# Beechcraft **CLASS I SERVICE INSTRUCTIONS**

**No. 0448-211, Rev. 1  
ATA Code 32-30  
Recurring Inspection**

**SUBJECT:** LANDING GEAR - MAIN GEAR RETRACT MECHANISM - INSTALLATION OF UP-LOCK ROLLER LUBRICATING BOLT ASSEMBLY.

Modification of Main Gear Up-Lock Cable Assembly Installation

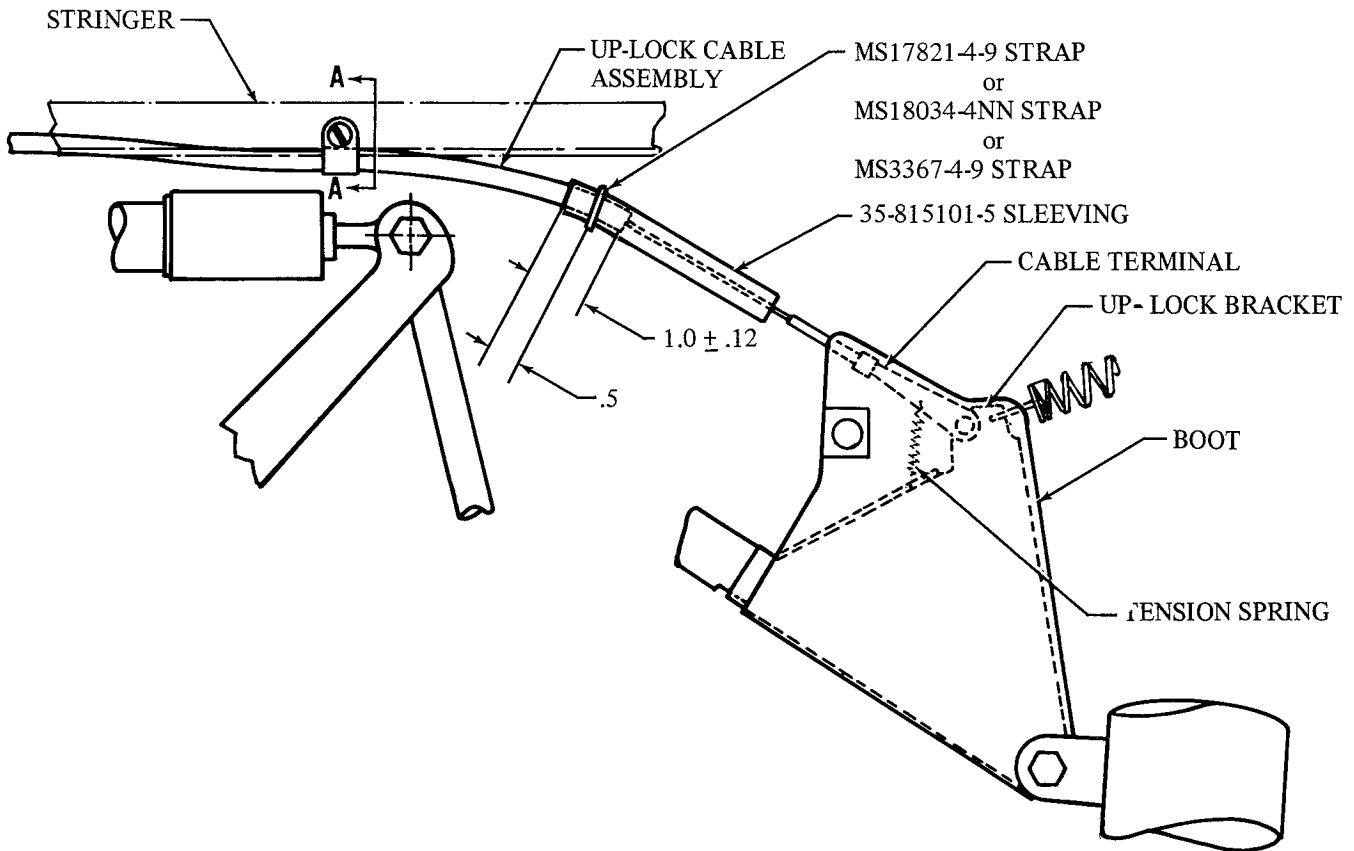
VIEW A-A  
 ON SINGLE-ENGINE AIRPLANES  
 IF ANGLE IS INSTALLED, DISCARD  
 ANGLE AND REINSTALL CLAMP  
 AS SHOWN AT RIGHT.

5. To prevent the up-lock cable from snagging on the up-lock roller lubrication fitting during cycling of the gears, modify the up-lock cable assembly installation as described below. (Refer to the illustration.)

c. Slip 35-815101-5 sleeving over the up-lock cable terminal and position on the up-lock cable assembly as shown in the illustration. Secure the sleeving with an MS17821-4-9, MS18034-4NN, or MS3367-4-9 strap (obtain locally).

f. On single-engine airplanes, check the up-lock cable assembly clamp installation shown in View A-A of the illustration. If the clamp is attached to an angle, remove and discard the angle, then attach the clamp directly to the stringer as shown using existing clamp attaching parts.
